STAFF RECOMMENDATION 3624 Central Avenue February 21, 2018

Application: New construction – addition and outbuilding
District: Richland-West End Neighborhood Conservation Zoning Overlay
Council District: 24
Map and Parcel Number: 10405029600
Applicant: Brian Hadfield, Owner
Project Lead: Sean Alexander, sean.alexander@nashvill.gov

Description of Project: The applicant is proposing to construct a rear addition to an historic house, and to construct an outbuilding.

SHEET TITLE	
COMPLETE SIDE ELEVATIONS	
JOB NO. 1705.00	SHEET NO. A-8
DATE 02-05-18

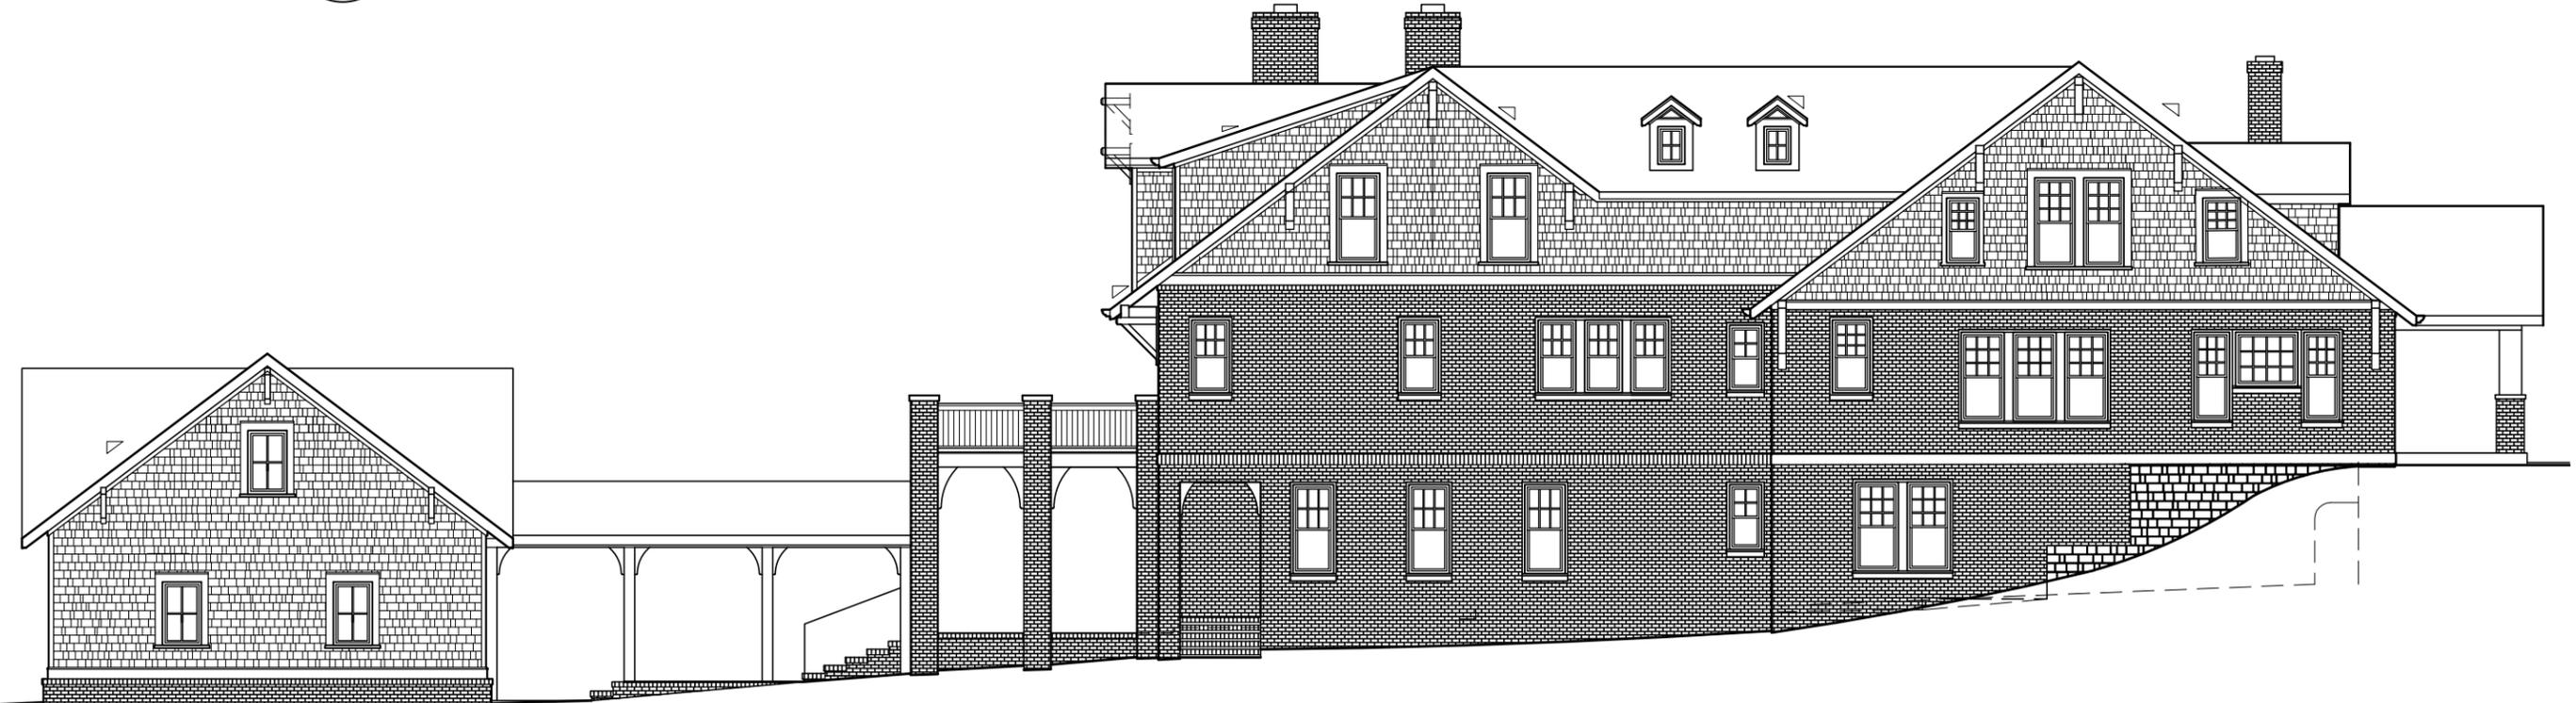
Location & Removability: The new addition will attach to the existing house at the rear, stepped in two feet (2') from the side walls of the existing house. The roof of the addition will tie into the rear slope of the existing roof, approximately six inches (6") below the existing ridge. Although the roof is not taller than the original roof, the drop in grade toward the rear of the lot allows the addition to effectively have three levels including the basement. The depth of the addition will be thirty-eight feet (38'), approximately one foot (1') less than the depth of the original building. A fifteen foot (15') deep uncovered porch will be located at the rear of the building at the main first story level. Staff finds the location of the proposed addition to be appropriate, and the impact on the original building to be minimal because it is stepped in from the sides and will not impact the front or sides of the building. Staff finds that the project meets sections II.B.2.a and II.B.2.d of the design guidelines.

Roof form: The new roof will be a side-oriented gable with a pitch of 9:12. The original roof has a side-oriented gable with the same pitch. The eaves of the addition will be higher than those of the original house to accommodate a larger second floor level, however the visibility of the eaves will not contrast greatly because the side walls of the addition are stepped in two feet (2’). Staff finds the roof forms to be compatible with those of surrounding historic houses and to meet section II.B.1.e of the design guidelines.

SHEET TITLE	
ELEVATIONS HOUSE FRONT & REAR	
JOB NO. 1705.00	SHEET NO. A-9
DATE 02-05-18

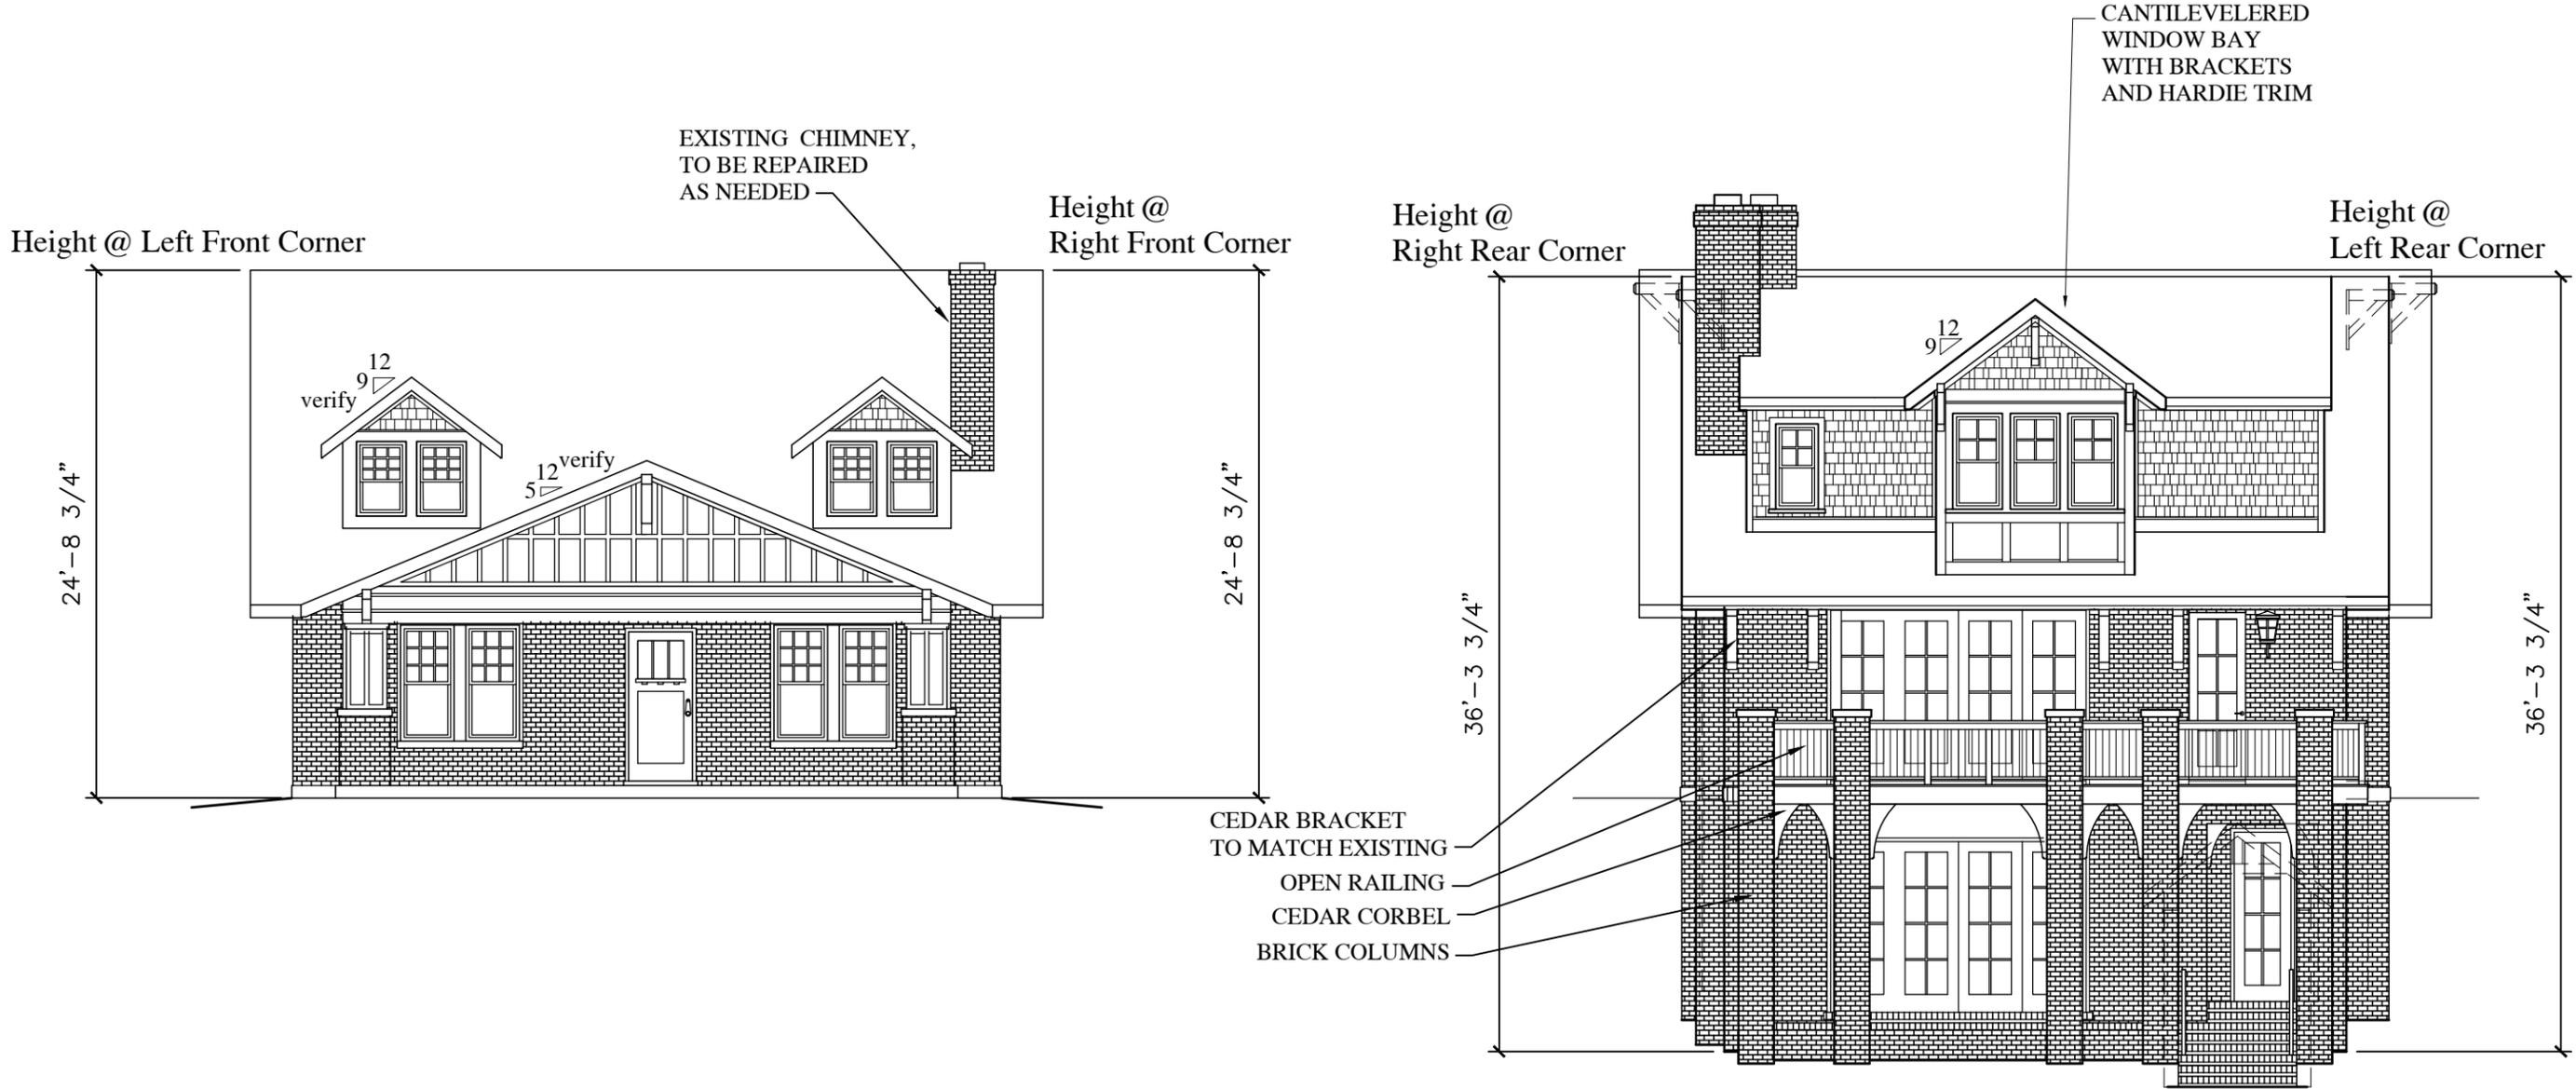
Proportion and Rhythm of Openings: The plans indicate that the existing windows are to be repaired as needed, but no alteration to existing window and door openings were indicated on the plans. The windows on the proposed addition are all generally twice as tall as they are wide, similar to the proportions of historic window openings. There are no large expanses of wall space without a window or door opening. Staff finds the project’s proportion and rhythm of openings to meet Section II.B.1.g.

SHEET TITLE	
ELEVATIONS GARAGE	
JOB NO. 1705.00	SHEET NO. A-13
DATE 02-05-18

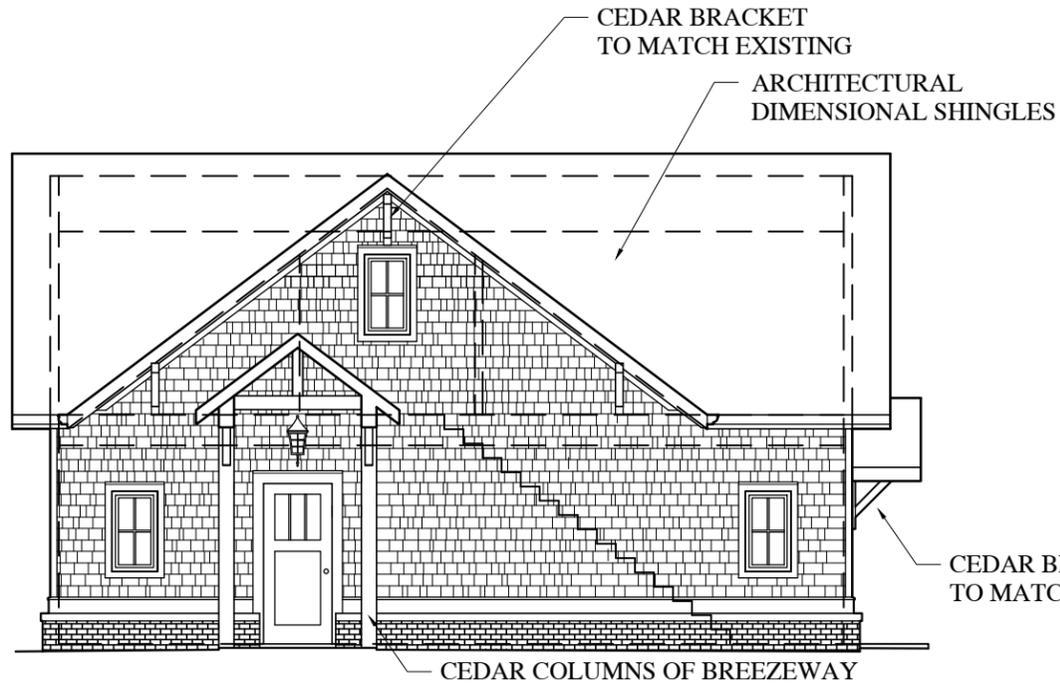
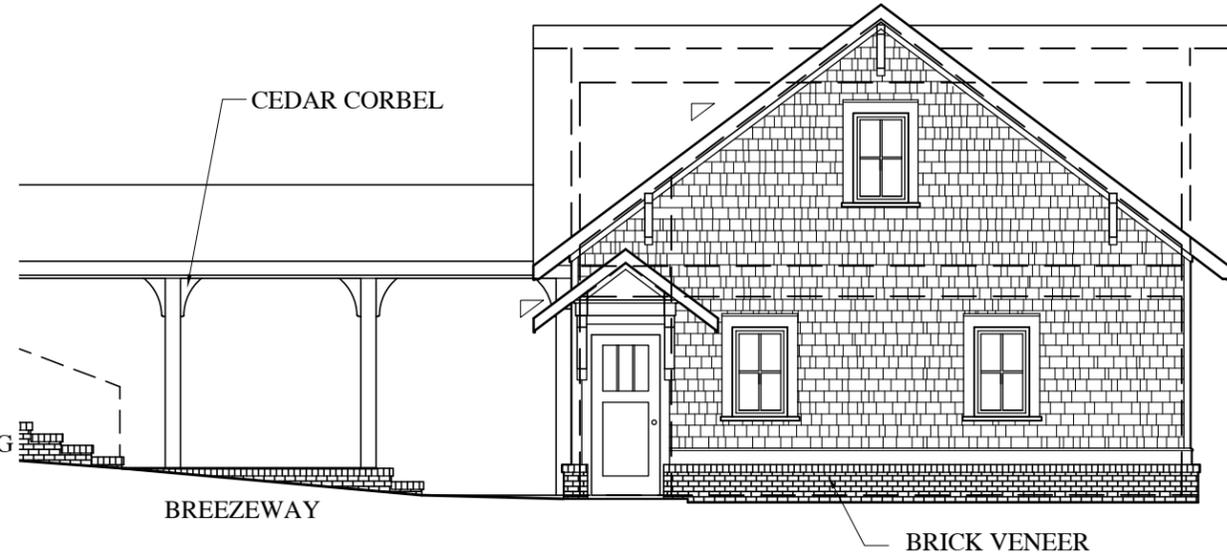
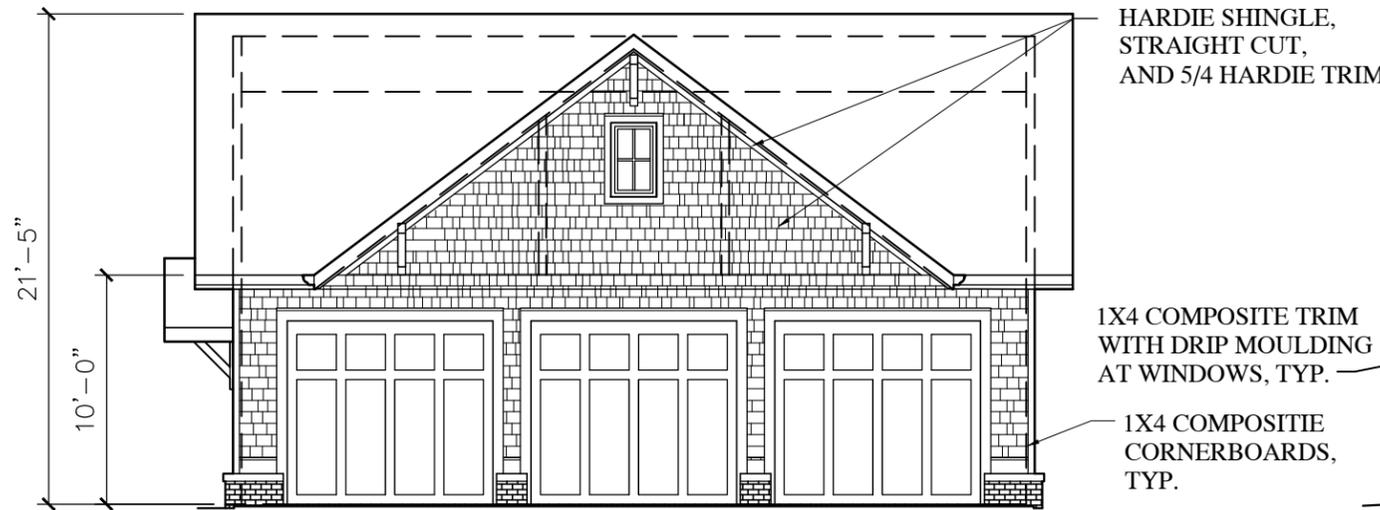
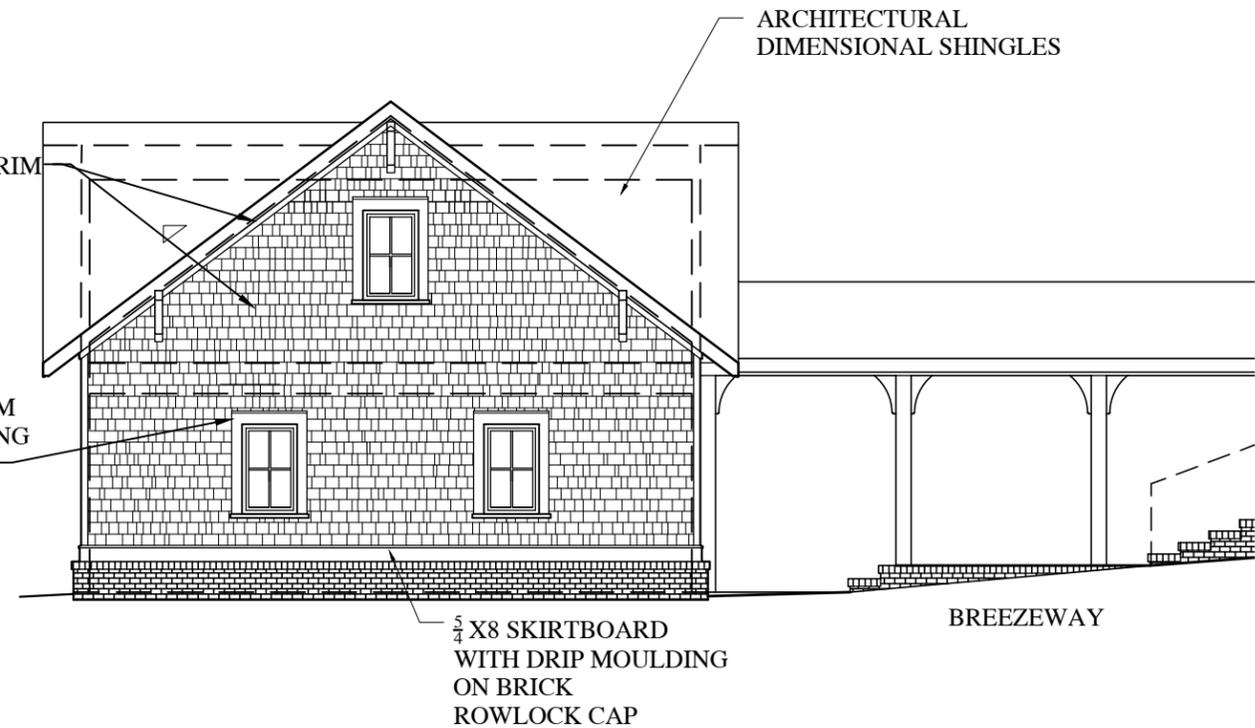
Outbuilding: The proposal includes a one and one-half story outbuilding at the rear of the lot. It will be detached, with an open-sided and uncovered walkway between it and the principal dwelling. The Commission has previously found similar covered walkway connectors to be appropriate in rear yards when they are less than six feet (6') wide and have open sides. The outbuilding will be one and one-half story with a cross-gabled form. The roof pitch will be 9:12, matching the pitch of the roof on the house. The building will have a footprint size of nine hundred, ninety-two square feet (992 sq. ft.), with an eave height of ten feet (10') and a roof height of twenty-one feet, five inches (21'-5). This is subordinate to the historic house which has a roughly one thousand, five hundred square foot (1,500 sq. ft.) footprint originally, and meets the design guidelines which allow an outbuilding to be up to one thousand square feet (1,000 sq. ft.) in footprint area based on the size of the lot. The materials will match those of the house, including a brick foundation and water table, cement-fiber shingle siding and asphalt-shingle roof, with wood and composite PVC trim. The setbacks of the outbuilding will be seven feet, seven inches (7'-7") from the rear of the property, five feet (5') from the left side and nine feet (9') from the right. These setbacks are compatible with outbuildings historically. The building is not proposed for use as a dwelling. Staff finds the location, size, character, and materials of the outbuilding to meet design guideline II.B.1.h.1 and II.B.1.h.2 for outbuildings.
